College for Certain, LLC

Cap Modification Plan Addendum

Former Pacific Electric Motors Facility, 1009 66th Avenue, Oakland, California
(Fuel Leak Case Number RO0000411)

December 3, 2014

FIGURE
3

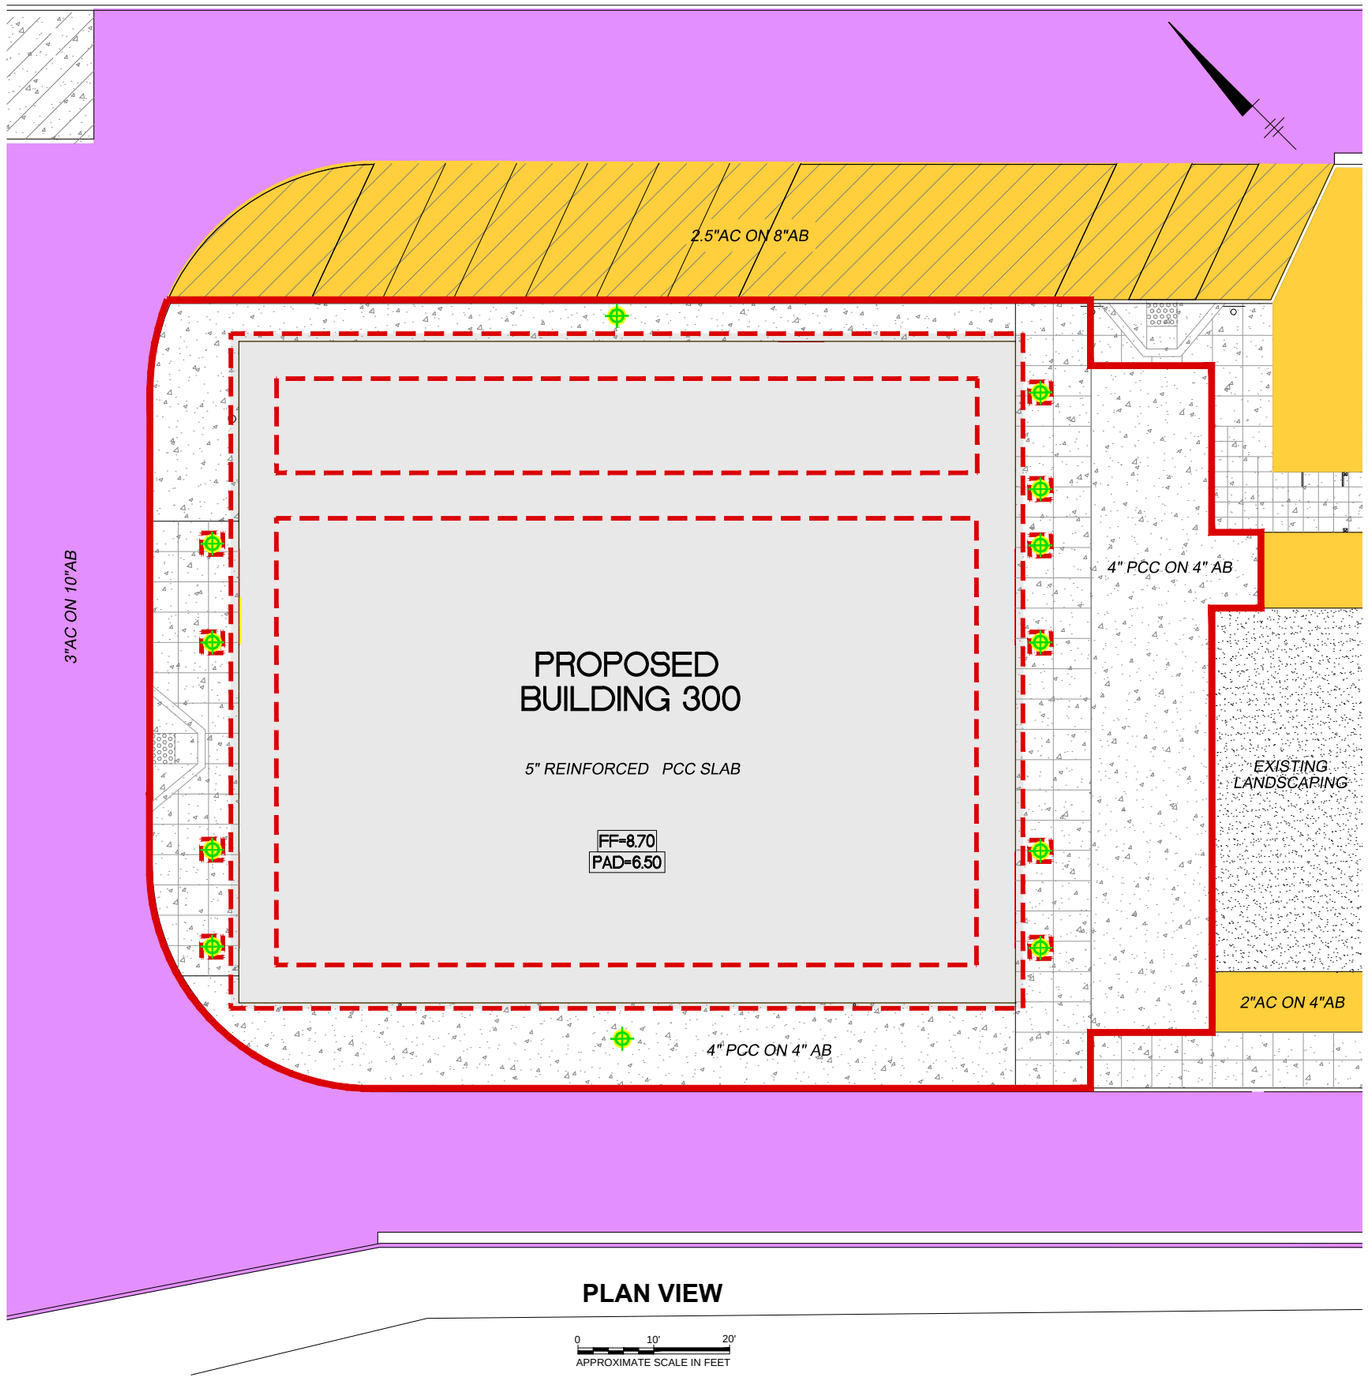
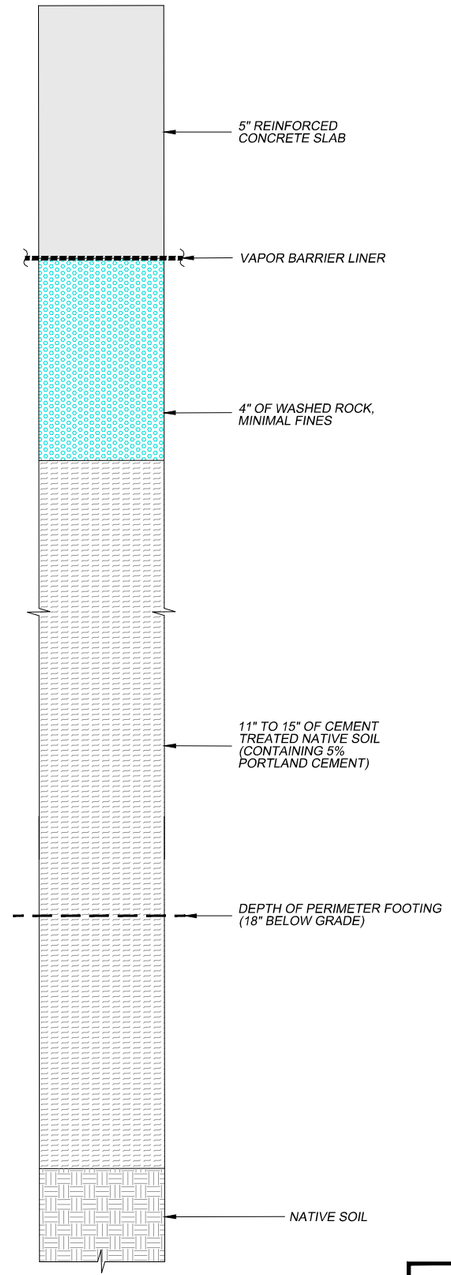
- Fourteen additional soil boring locations were added to the area of the proposed building footprint (Figure 3); soil samples will be collected only from the cement-treated native soil layer.

- Soil samples will be collected only from the cement-treated native soil layer for the two sample locations outside of the proposed building footprint (Figure 3).

ARCADIS will advance an additional fourteen soil borings to a depth of between 0.5 and 1.0 feet bgs. Soil boring locations are shown on Figure 3. The proposed locations are positioned within the proposed building footprint in a 25 feet by 25 feet hexagonal grid.

The demolition plan includes the disturbance or removal of the existing cap located at Building 300 (see Figure 3). ARCADIS conducted a review and updated the estimated quantities of cap materials that will be generated as part of the CMP. The updated table is presented below.
